SUITE: 302

CONSTRUCTION SUMMARY

Forestside Estates Inc.

LOT NUMBER	PHASE	HOUSE TYPE	CLOSING DATE
302 BLOCK 1	6-III	Red Pine 2D	10-Apr-23

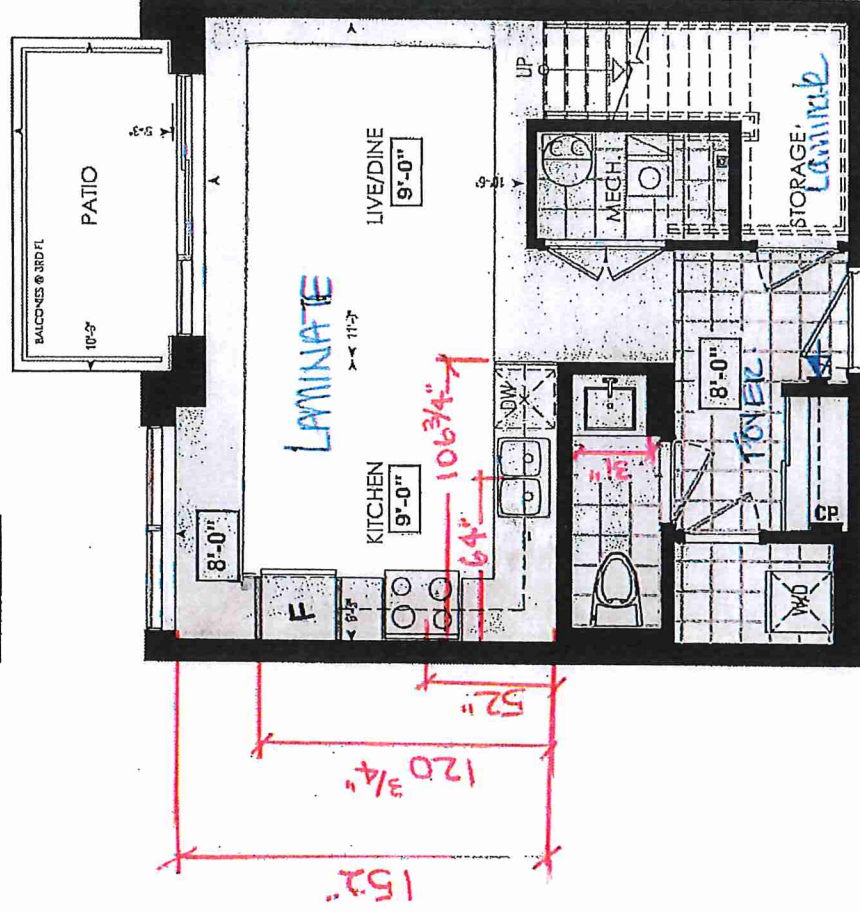
LOCATION OF
KITCHEN LIGHTS
REFER TO
KITCHEN DWG.

KITCHEN PLAN ~~20~~, ~~20a~~, 2D

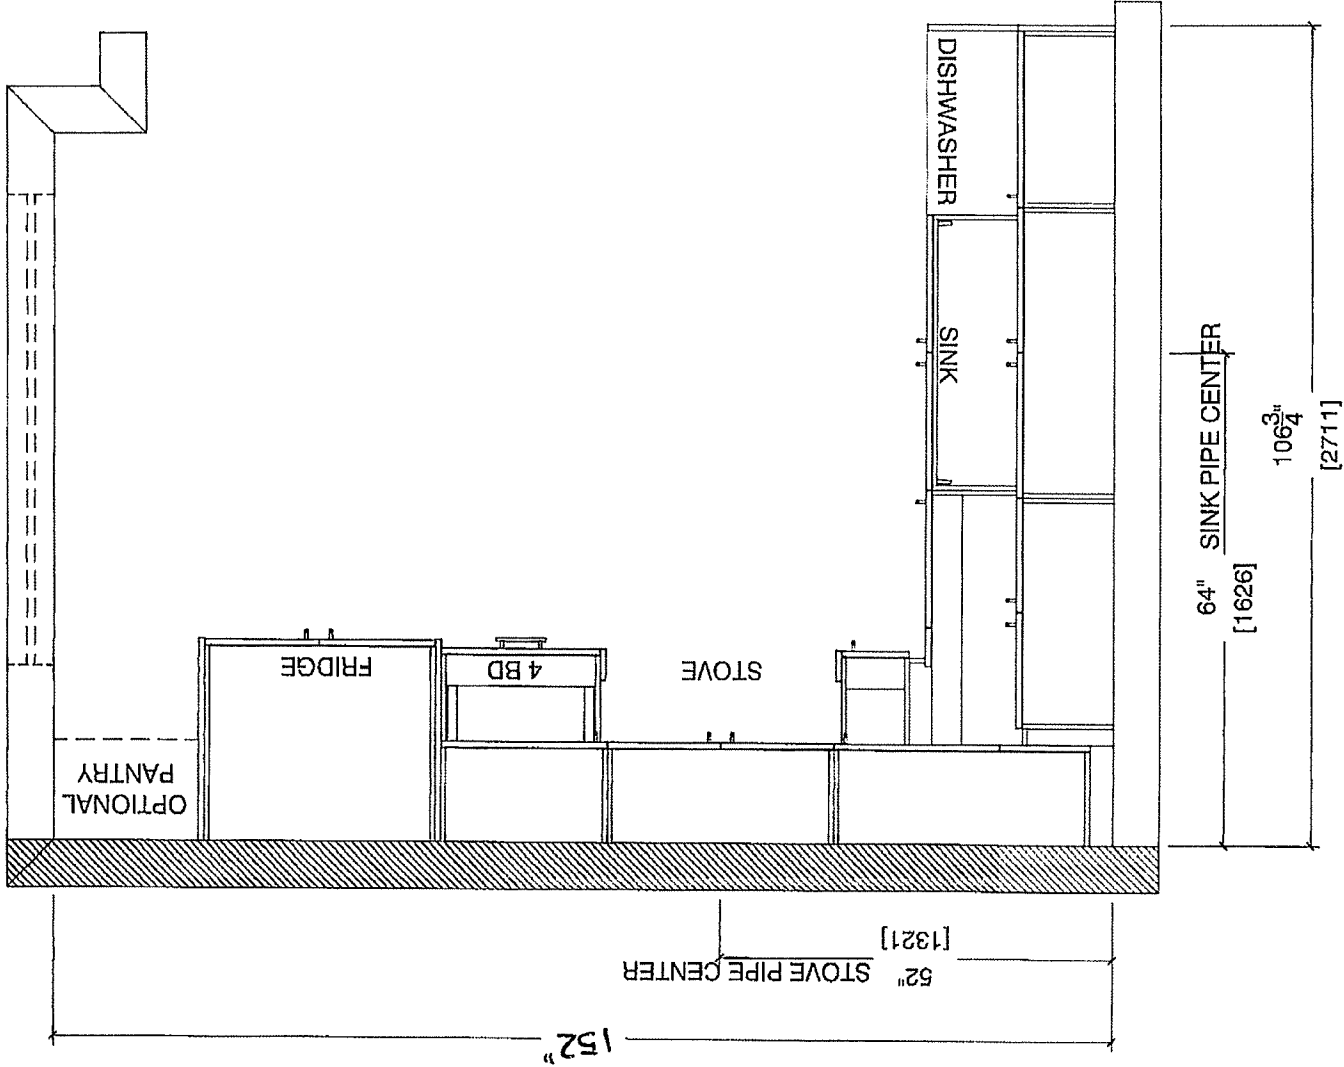
Note : Model-type 2D cannot have an optional pantry due to window configuration
